ADDENDUM No. 1

March 28, 2016

Little Sisters of the Poor Main Street Renovations
601 Maiden Choice Lane, Baltimore MD 21228

Project No: 15046.00

PN: 15046.00	DATE: 03-25-16
Reference Dwg:	A-111
DWG. NO.	A-SK-111-01

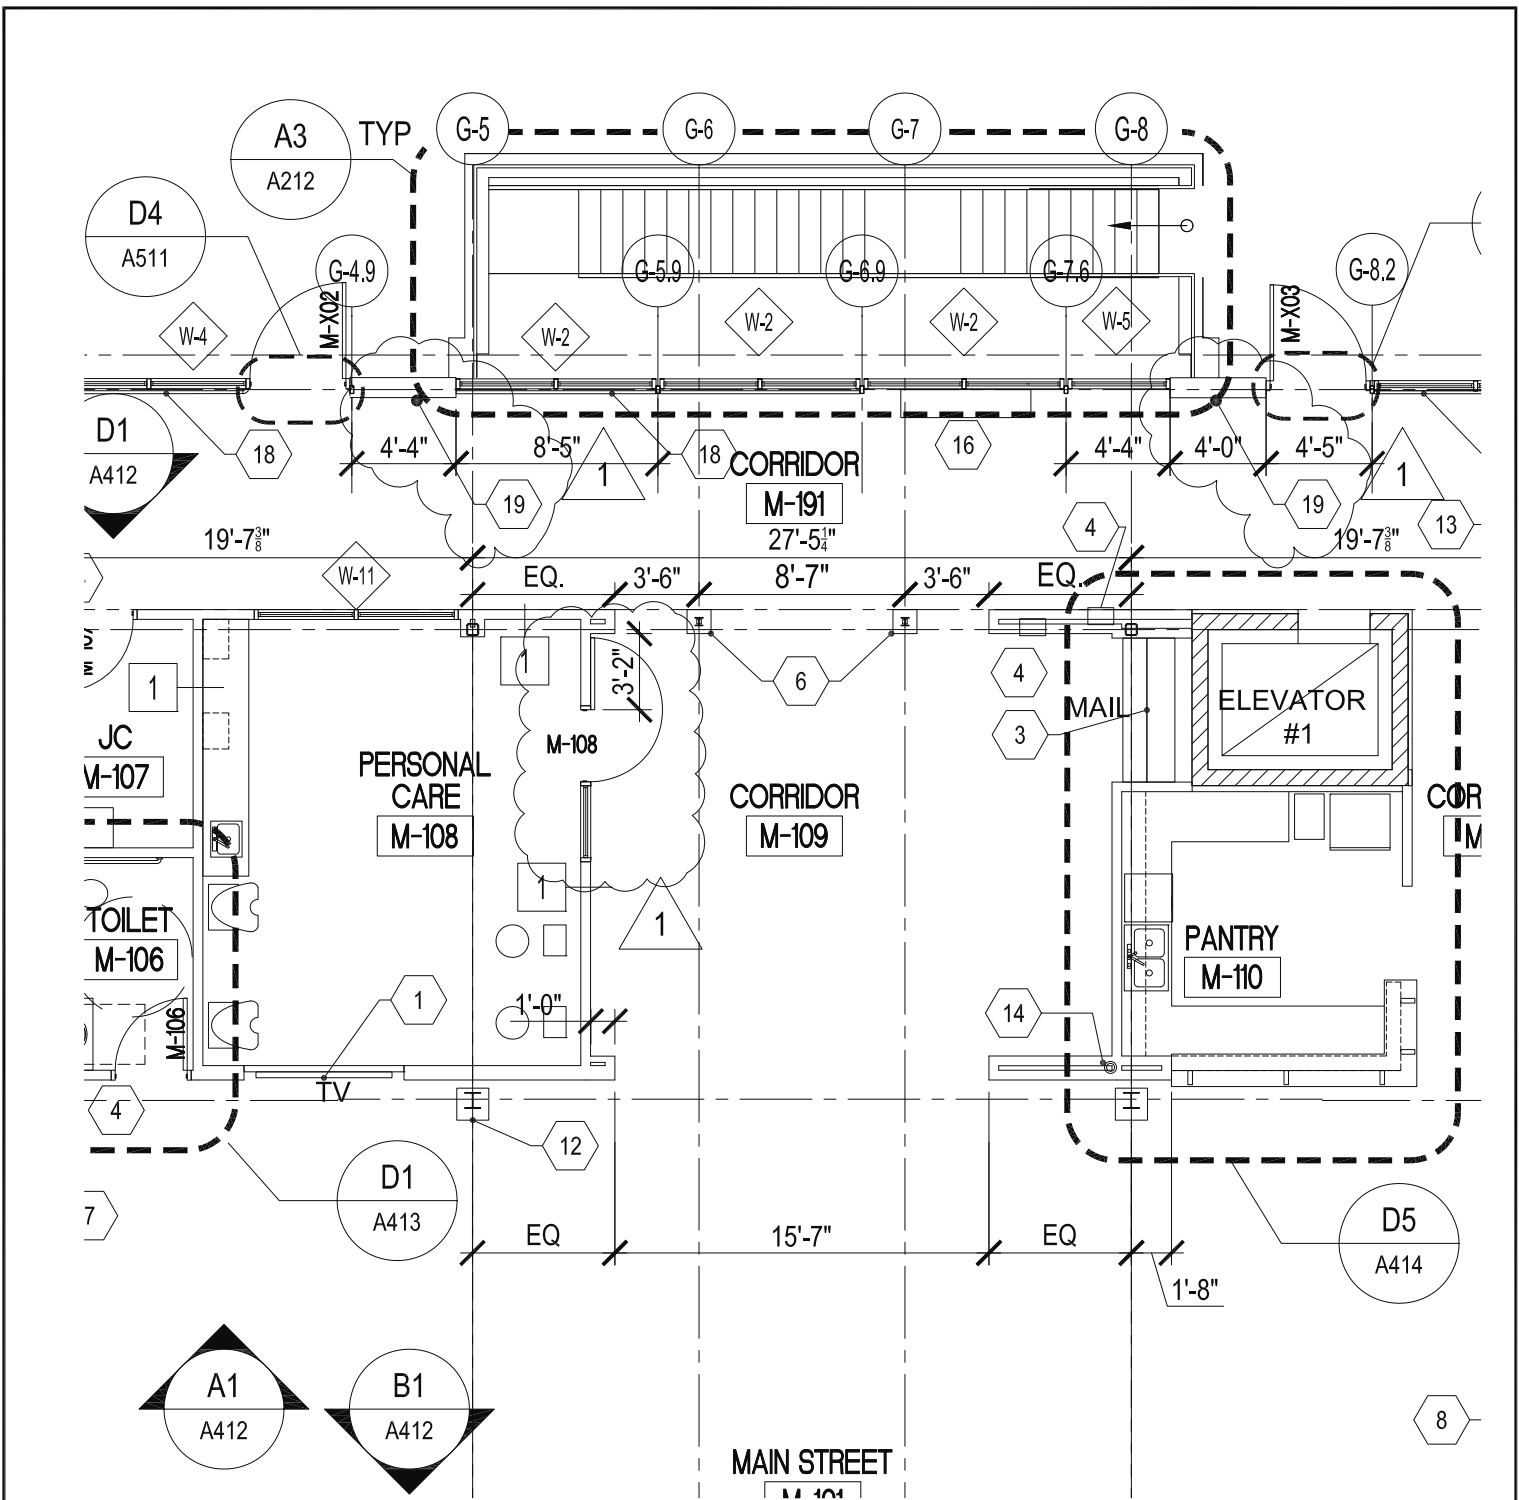
1. Drawing A-111: see attached sketches:
 - a. Add new drawing note 19 as follows: "NEW EXTERIOR WALL, SEE B2/A-512 FOR DETAIL"
 - b. A-SK-411-01: Door to Personal Care M-108 was revised; new exterior wall was clarified (note 19).

PN: 15046.00	DATE: 03-25-16
Reference Dwg:	A-111
DWG. NO.	A-SK-111-01

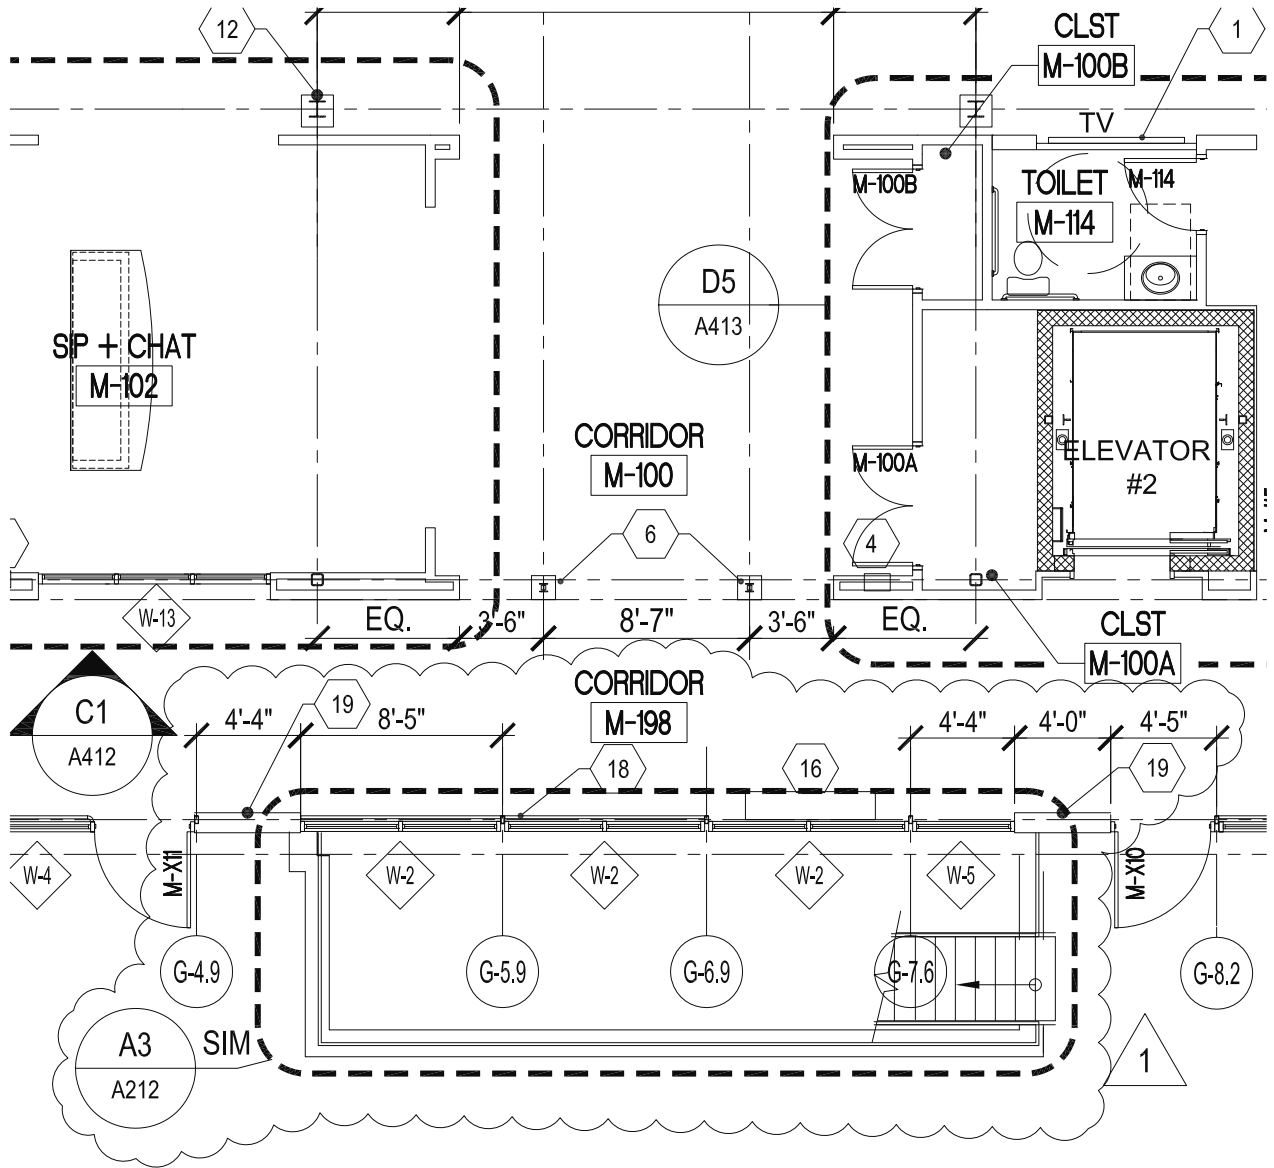
- c. A-SK-411-02: Enlarged detail A3/ A212 (sim) was referenced; dimensions were added and new Door to Personal Care M-108 was revised; new exterior wall was clarified (note 19).

DWG. NO.
A-SK-111-03

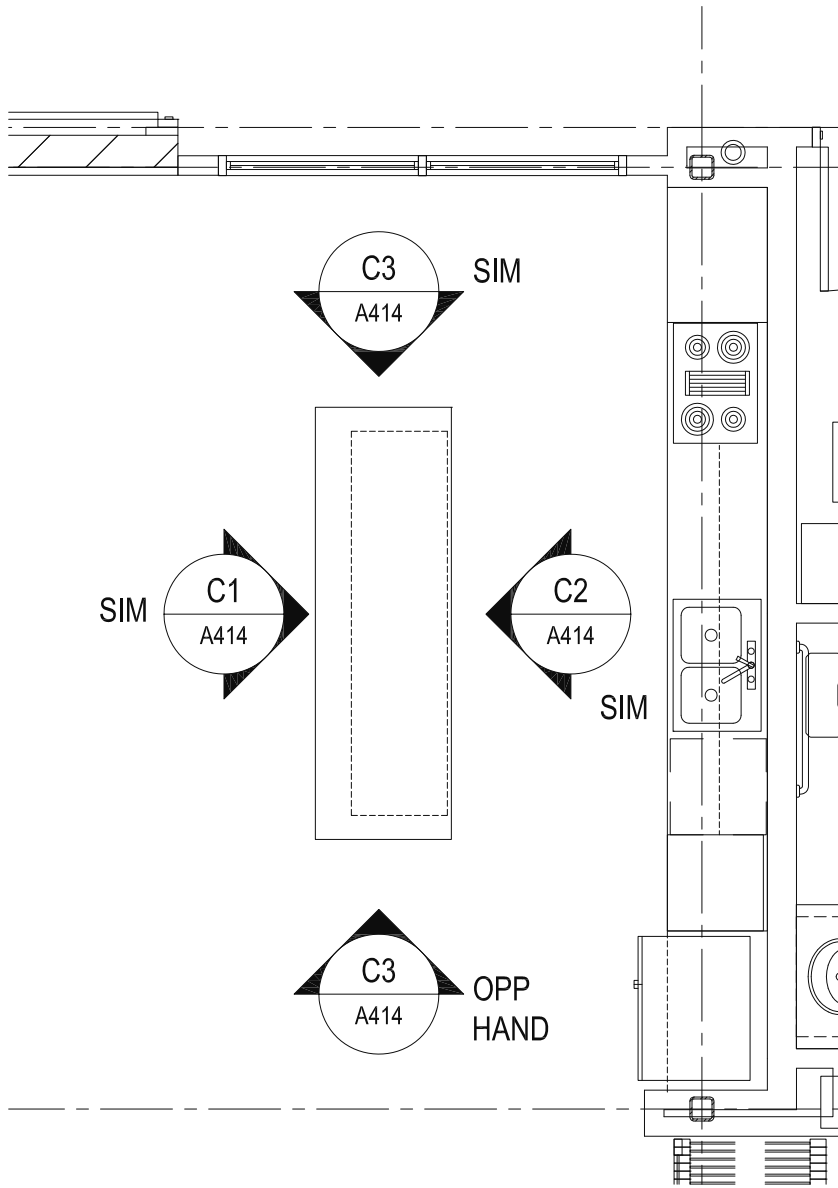
- e. A-SK-411-03: See attached sketch for clarification of the casework elevations for the island in Games/ Hobby.
2. Drawing A-112:
 - a. Clarification for Note 3, new handrail: locate new handrail at new exterior storefront, typical except where a handrail would conflict with the new fan coil units.
